VSP-32

Subject: B. F. Goodrich Service Bulletin No. 399 (Improved Wear Limit of
2-1435-2 MLG Brake on Piper PA-31T2 Cheyenne II XL and
PA-42 Cheyenne III)

SERVICE BULLETIN

BRAKE REMOVAL WEAR LIMIT

Figure 1.

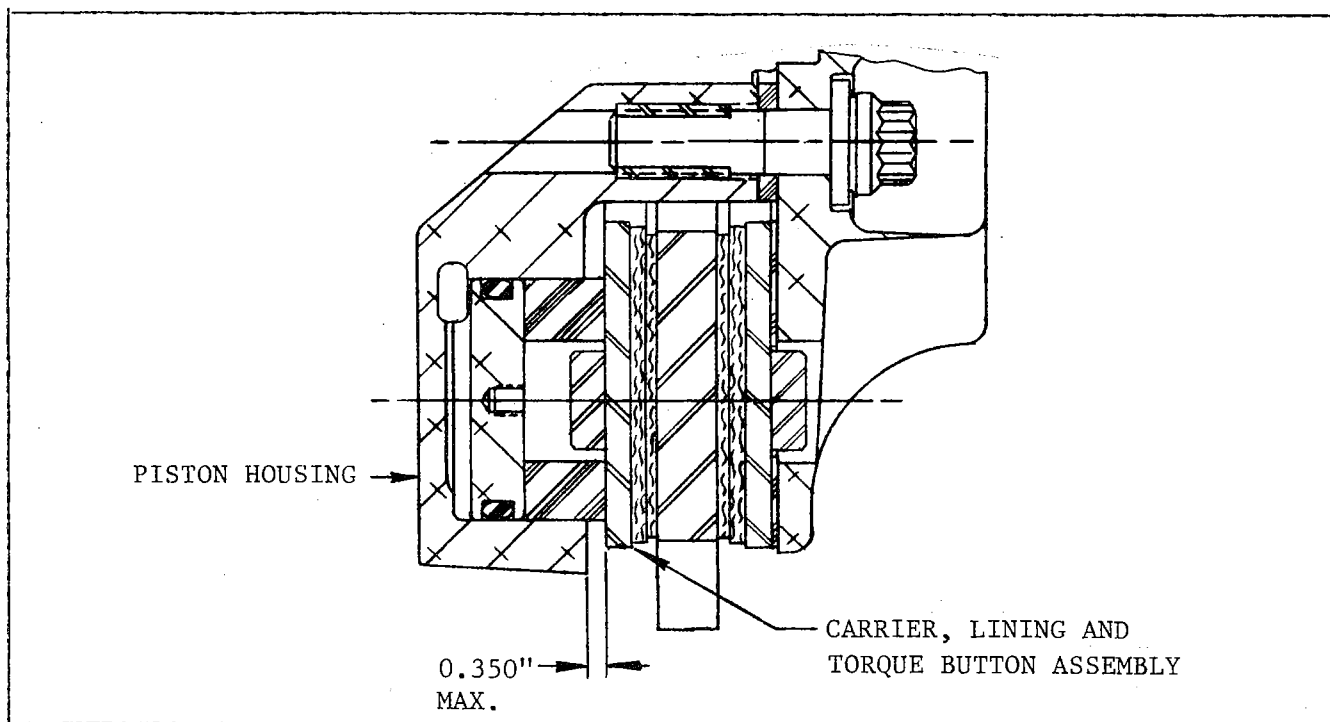
PURPOSE: To inform users of 2-1435-2 MLG Brakes of an improved wear limit allowing maximum service before overhaul.

SCOPE: Premature brake removal for worn lining condition has resulted in overhaul of brakes that were still serviceable. The new wear limit will provide maximum service life and prevent premature removal for overhaul.

- 1 - Pressurize brake to 100 psi.
- 2 - Measure distance between the carrier, lining and torque button assembly and the piston housing (as shown in Figure 1.).
- 3 - A 0.350 inch measurement indicates brake is ready for overhaul.
